SERVICE BULLETIN

Notification Number: **SB-12-01-08-1**

Subject: **Sensenich Ground Adjustable Propellers. Reference attached Sensenich Service Memo # C08-1A**

Service Memo C08-1A

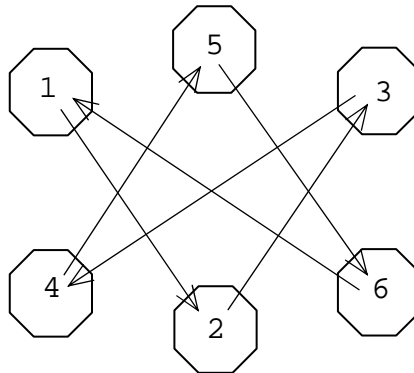
Using a calibrated torque wrench and following the pattern shown below. Tighten the bolts in $\frac{1}{4}$ to $\frac{1}{2}$ turn increments (this will take several passes) until the proper torque given in **Table 1** is reached. It is important to maintain an even gap between the hub halves.

Recent incidents of hub clamp bolt failures used to secure the propeller hub halves have prompted Sensenich Propeller Mfg. Company Inc. to issue a service memo to replace and torque to 28-30 Ft-lb. the (6)-AN6-15A clamp bolts every **10 hours** of operation. Please call (717-569-0435) or email (sales@sensenich.com) the Sensenich Propeller Mfg. Company Inc. for replacement bolts at no cost.
